CITY OF CONWAY, ARKANSAS HISTORIC DISTRICT COMMISSION

HISTORIC DISTRICT COMMISSION

November 28, 2022

2024 Weems Street - New Single-Family Residence

2 SOUTH ELEVATION
SCALE: 1/8" = 1'-0"

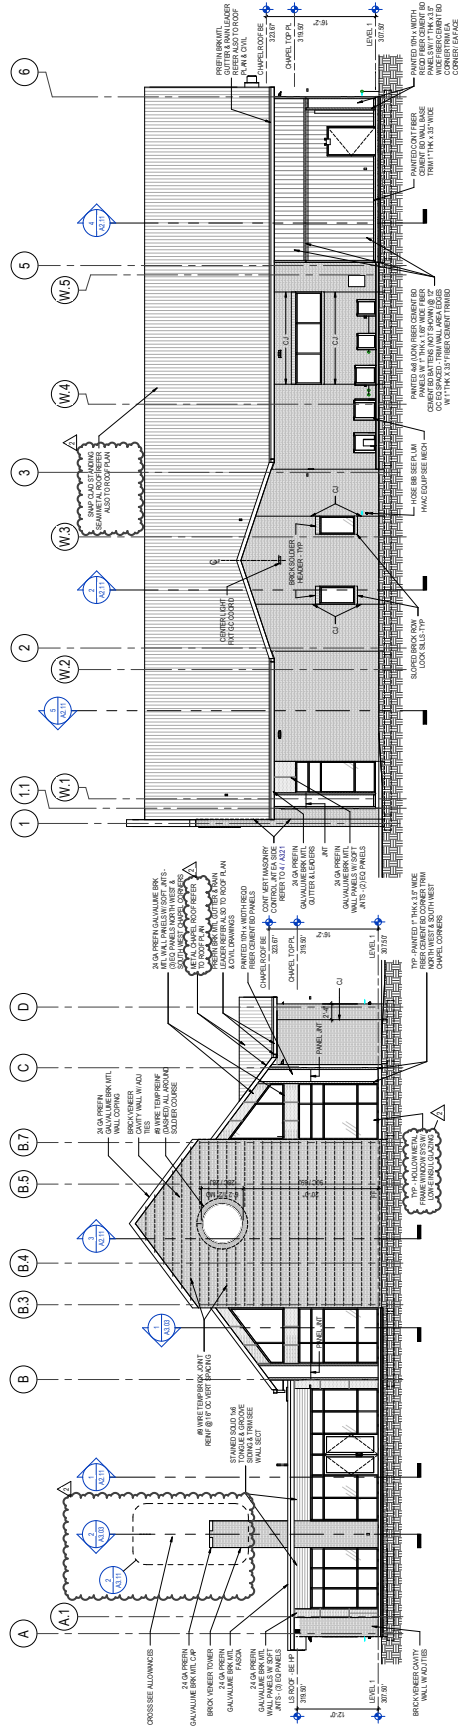
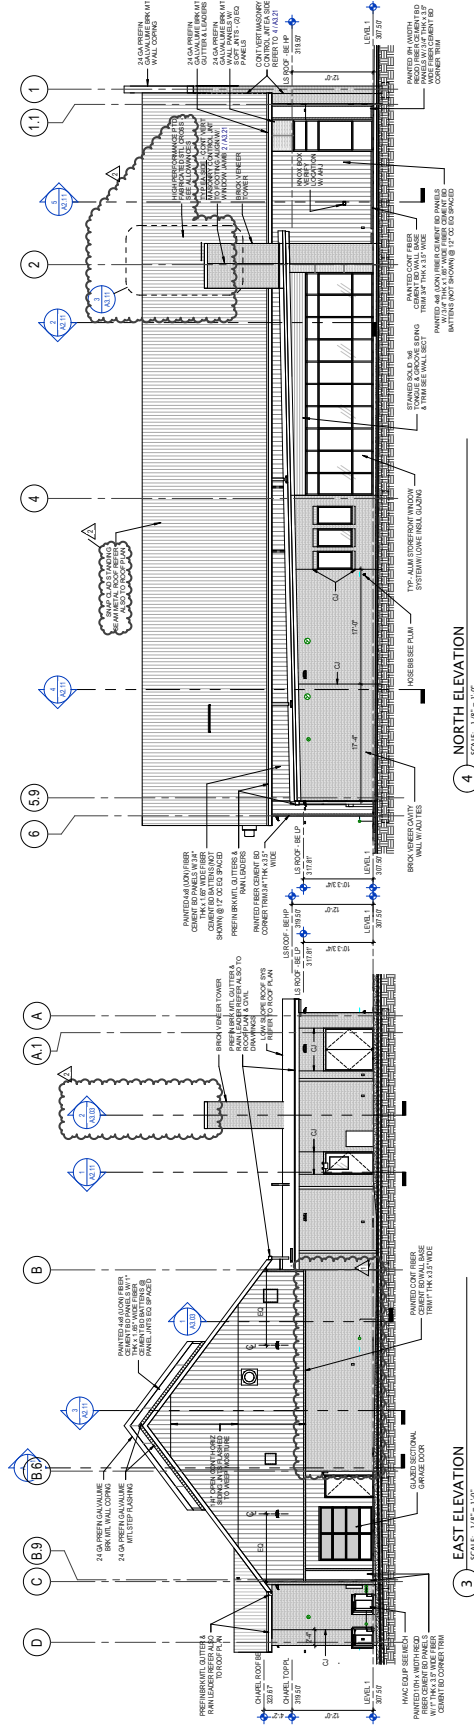
General Description of Property and Proposed Development. The applicant is proposing to make modifications to the previously approved plans to construct a new 7,761 sf student religious facility for the Catholic Campus Ministry. The existing approval provides allowance for a shingle roof. The applicant would like to switch the roof materials to a metal standing seam roof.

Existing structures in the immediate vicinity feature shingle roofs. However, various religious uses in Old Conway feature standing seam metal roofs.

Staff recommends approval of the project.
